DOS OSOS RESERVOIR REPLACEMENT PROJECT ORINDA, CALIFORNIA

FINAL MITIGATED NEGATIVE DECLARATION

EAST BAY MUNICIPAL UTILITY DISTRICT

October 2017

<u>Figure 3.1 Locations of viewpoints of the new dual Dos Osos Reservoirs from the De La Veaga Trail, the horse corral and Lomas Cantadas.</u>

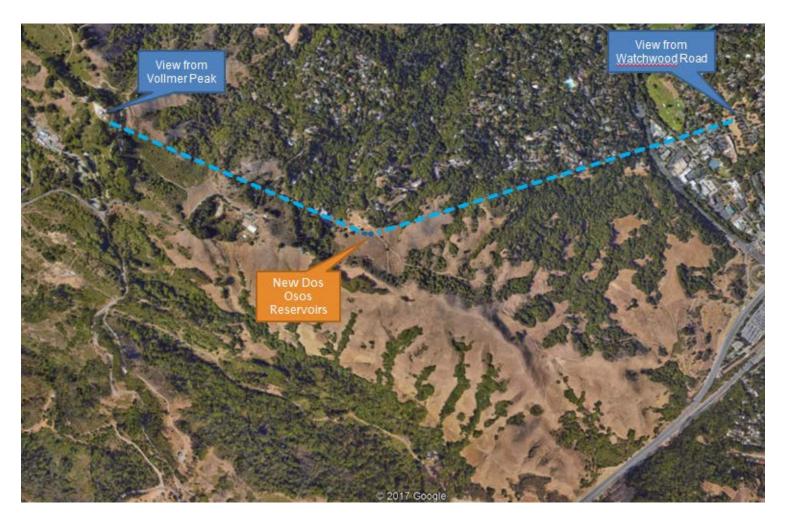
In response to this comment and the subsequent Comment Bowen-4B, Figures 3.1 through 3.8 are added to Section I, Aesthetics, of the MND to provide visual simulations of primary viewpoints of the new dual reservoirs. Figures 3.1 and 3.2 show the locations of the viewpoints of the simulations in relation to the new dual reservoirs site. Figure 3.3 shows the simulated view of the new reservoirs from the De La Veaga Trail 500 feet southeast of the new reservoirs. From this vantage point, only the upper portions of the new reservoir tanks will be visible. Figure 3.4 shows the simulated view of the new reservoirs from a pedestrian gate along the De La Veaga Trail (approximately 1,000 feet away) on the ridge above the new reservoir site. From this vantage point, only small portions of the new reservoirs will be visible through the existing tree line between the ridge and the new reservoirs. Both views of the new reservoirs from the De La Veaga Trail will be minimal given the existing hillslope topography and vegetation; thus, impacts from short- and long-distance views from the trail are less than significant.

<u>Figure 3.5a Existing view from horse corral. This photo shows the existing view of the new Dos Osos Reservoirs site from a horse corral approximately 150 feet away from the site.</u>

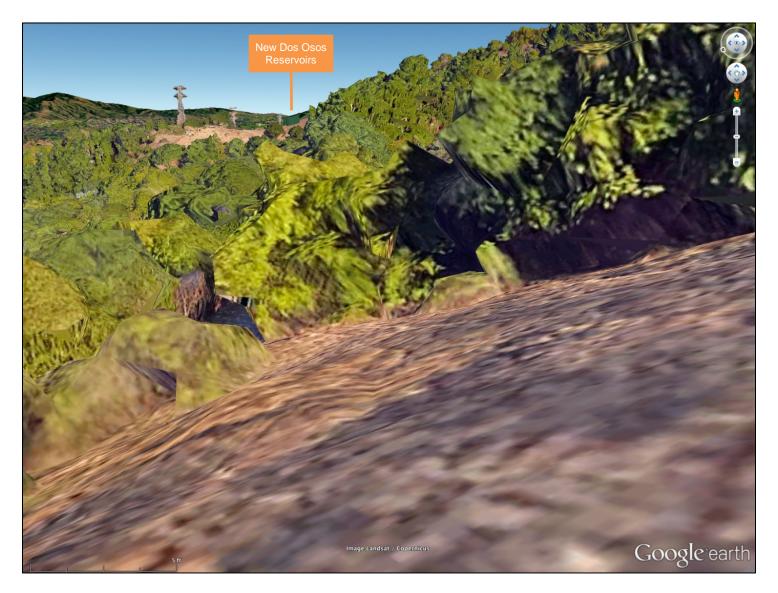
The comment states that the "Large earthen berms and out of context trees atop a scenic ridgeline would present a significant impact to aesthetic resources of the project area." From the short-distance view shown in Figure 3.5a, the proposed earthen berms and trees, while visible, will integrate into the existing landscape, as described above, and view impacts on sensitive receptors will be less than significant. From long-distance views, the proposed earthen berms and planted trees will be indiscernible from the surrounding landscape and vegetation.

<u>Figure 3.5b Simulated view from horse corral. This photo simulation of the new Dos Osos Reservoirs site shows the new dual reservoirs, retaining wall, security fencing, constructed earthen berms, and planted trees. The viewpoint is from a horse corral approximately 150 feet away from the site.</u>

Figure 3.8 Simulated view from Vollmer Peak. This visual simulation shows the view of the new Dos Osos Reservoirs from Vollmer Peak, approximately 4,000 feet away from the reservoirs.

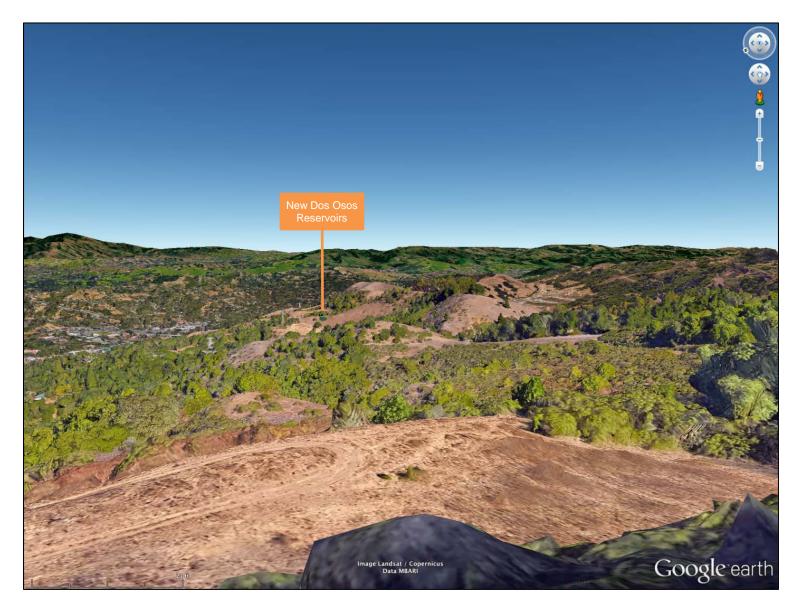
The comment also references views from Vollmer Peak. Vollmer Peak is roughly 4,000 feet away and 500 feet higher in elevation than the new dual reservoirs. Figure 3.8 shows the simulated view from Vollmer Peak of the new reservoirs site. While there is an unobstructed line of sight, given the distance and the exterior paint color and vegetated screening, the new reservoirs will be nearly indiscernible within the surrounding landscape. The comment also references downtown Orinda; however, given the existing hillslope topography southeast of the new reservoirs site, downtown Orinda will not have views of the new reservoirs.
